Planning Decisions Committee

6.30pm, Wednesday 13 October 2021

1. This report provides Council with an assessment of planning application PLN21/0271 which relates to land at 268-272 Church Street, in Richmond. The report recommends approval subject to conditions.

Image: Sightline diagram of proposed building viewed from the eastern footpath of Church Street.

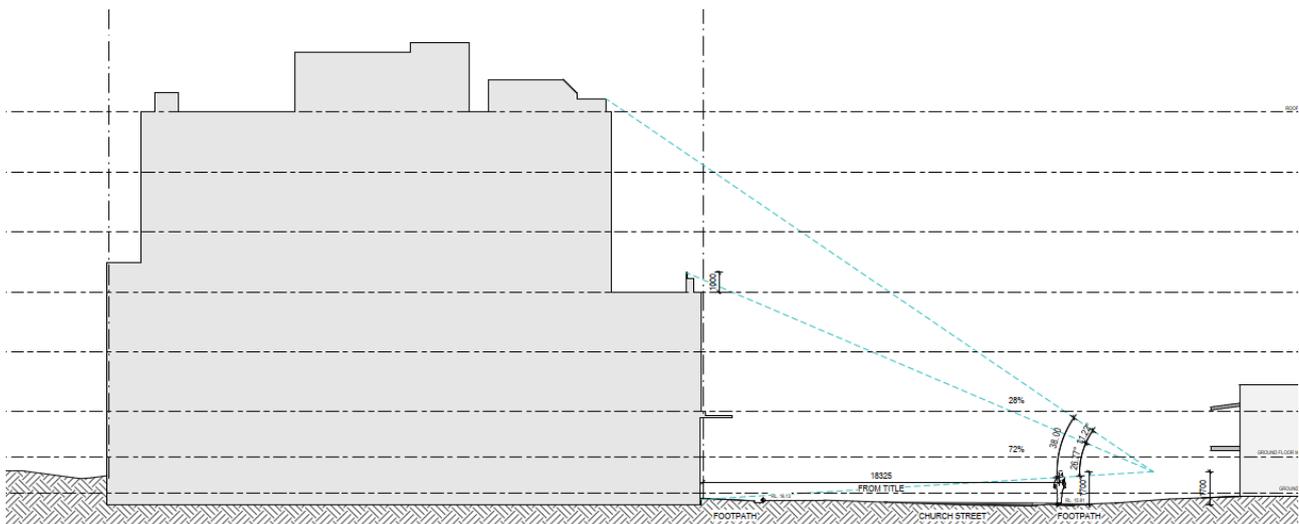
164. The Site does not contain a heritage building, is not affected by the Heritage Overlay (HO) and does not adjoin a heritage building. The discretionary 6 metre upper level setback requirement applies to properties affected and not affected by the HO.
165. Whilst the proposed development fails to meet the minimum upper level setback requirement, it successfully achieves the preferred DDO21 building massing outcome for upper levels along Church Street. This view is also shared with Council's urban design consultant, stated above.
166. This is due the upper levels of the proposed building occupying less than 1/3 of the viewline when measured from the eastern footpath of Church Street. A sightline diagram has been prepared by the Applicant, shown in the image below, which demonstrates compliance with this requirement.

Image: Potential raised threshold crossing the intersection of Church and Berry Streets.

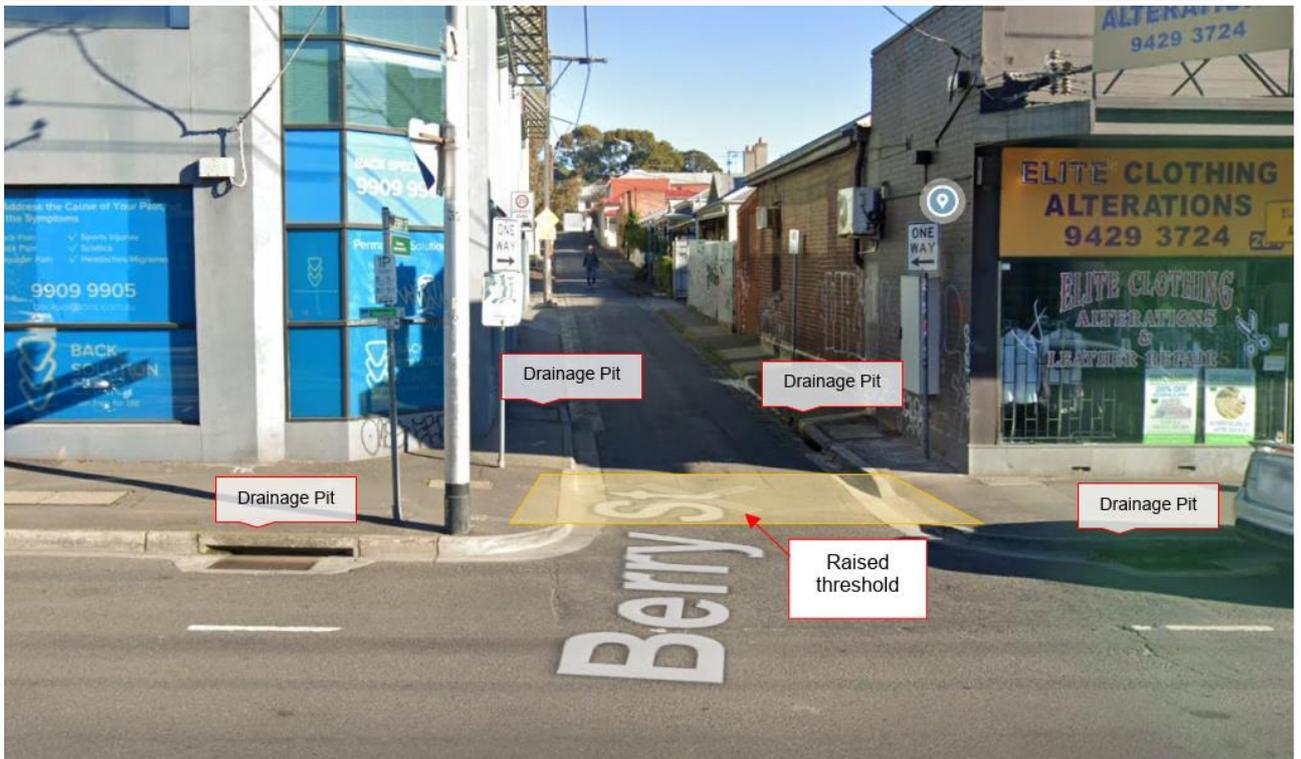
175. The Applicant has agreed to undertaking this public realm improvement, subject of course to an appropriate drainage outcome, which goes above and beyond the requirements of the Yarra Planning Scheme. A condition has been recommended to ensure these works are carried out to Council's satisfaction and the developer's expense.

Image: Proposed shadow diagrams: 10am (left), 10:30am (middle) and 10:52am (right). Red dashed outline is the advertised proposal shadow and blue dashed outline is the amended proposal shadow. Source: S57a architectural plans (Pages 87-89)

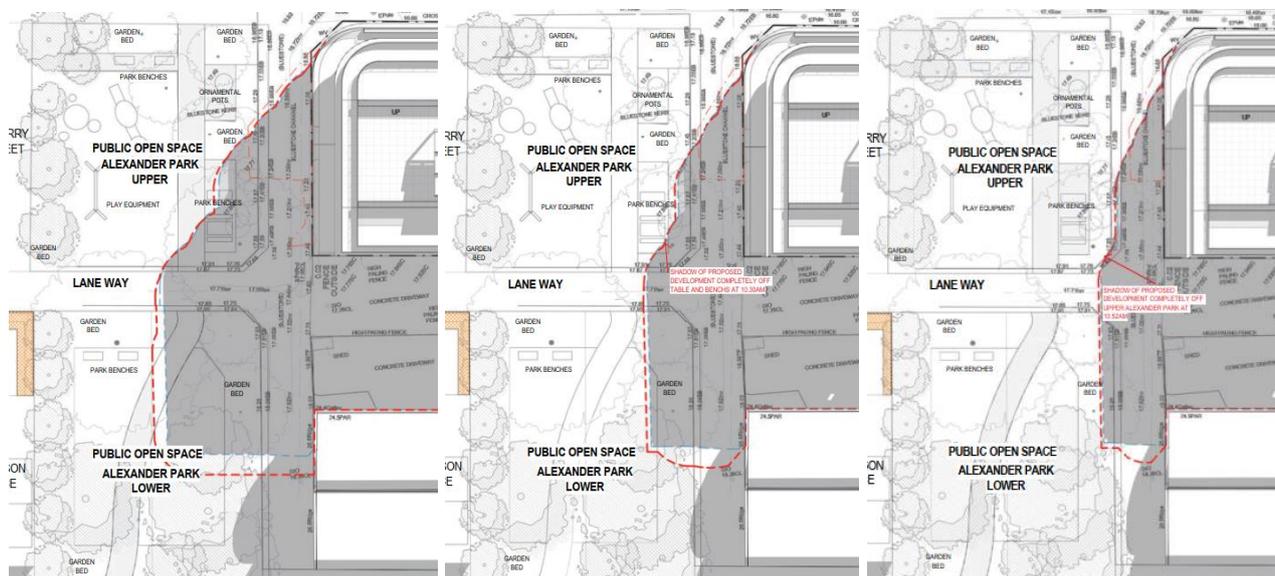
205. To visually show the location of the proposed shadow between 10:00am – 10:52am in relation to the reserve, extracts of the shadow diagrams of the S57a plans are provided below:

206. It is clear that the principal shadow cast on the reserve by the amended proposal is generally limited to between 10:00am (119m²) and 10:30am (46.5m²) at the Equinox. After 10:30am, the overshadowing impact is largely limited to the eastern garden bed of the southern portion of the reserve. No shadowing impact occurs on the reserve after 11am. It is also important to understand that the shadow diagrams do not contemplate shadow impacts from the existing established trees scattered throughout the reserve.

Figure 3: Overshadowing diagrams at 12pm (left) and 3pm (right)

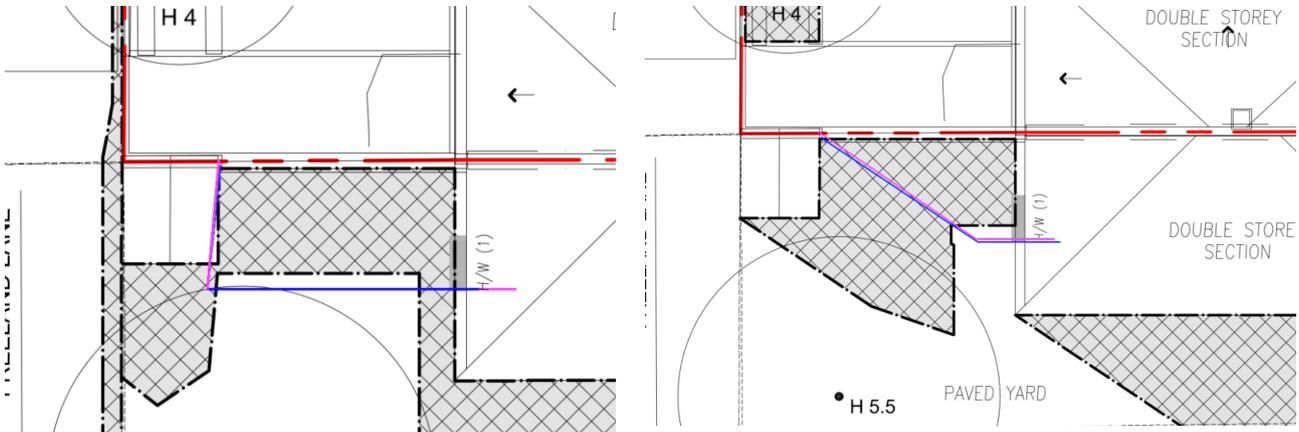
33. These shadow diagrams were assessed against Council's overshadowing template in the computer program Objective Trapeze. At 9am, the shadow diagrams have been drawn correctly. However, at 12pm and 3pm, the extent of overshadowing appears to be marginally underestimated. Figure 3 below illustrates the extent of existing and proposed overshadowing measured in Objective Trapeze at 12pm and 3pm. The blue outline denotes existing shadow and the pink outline denotes proposed shadow.

Figure 5: Proposed ground floor plan showing the extent of the proposed southern boundary wall, constructed within title boundary (highlighted in red)

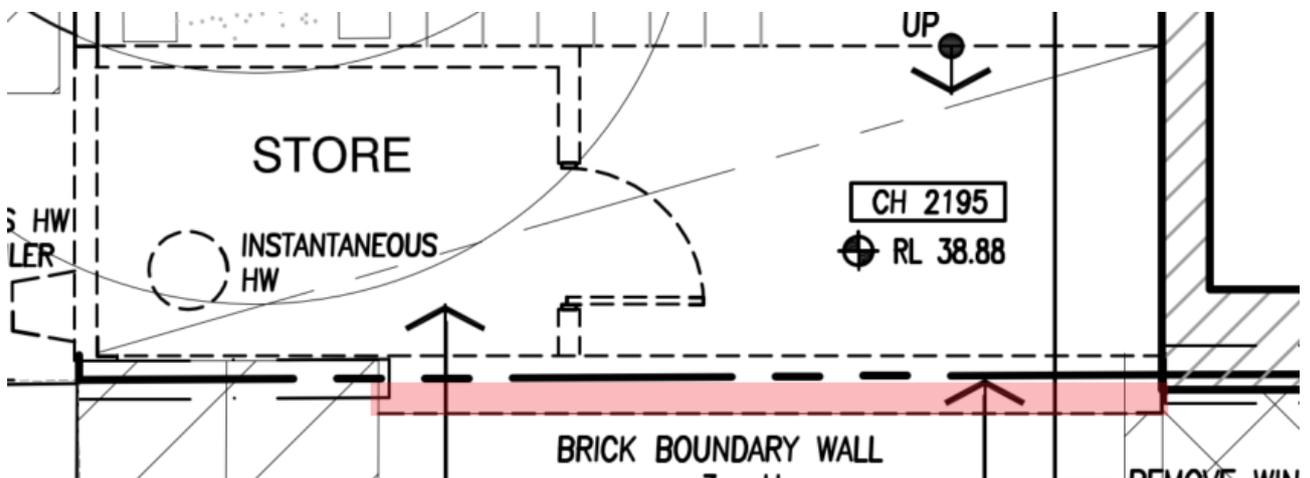
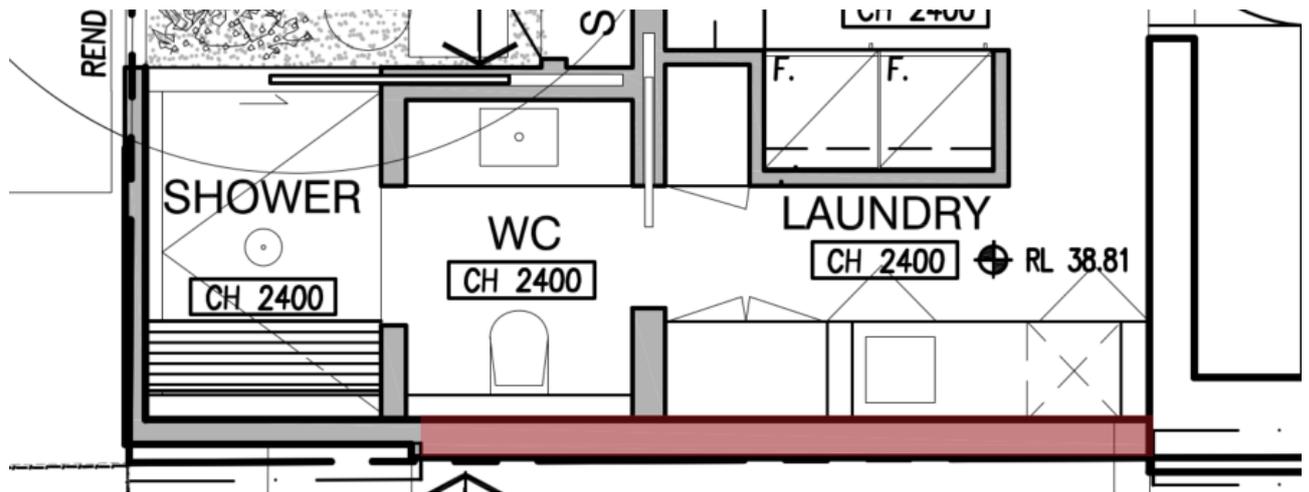
36. The existing southern boundary wall is partially constructed over the title boundary of No. 217 Gore Street (as illustrated in Figure 4 below), and the proposed southern boundary is constructed within the title boundaries of the subject site (as illustrated in Figure 5). As such, despite an increase in height of 0.2m, the proposed southern boundary wall has been set back from existing conditions and will not result in additional overshadowing of this SPOS. The proposed southern boundary wall is therefore compliant with the Standard.
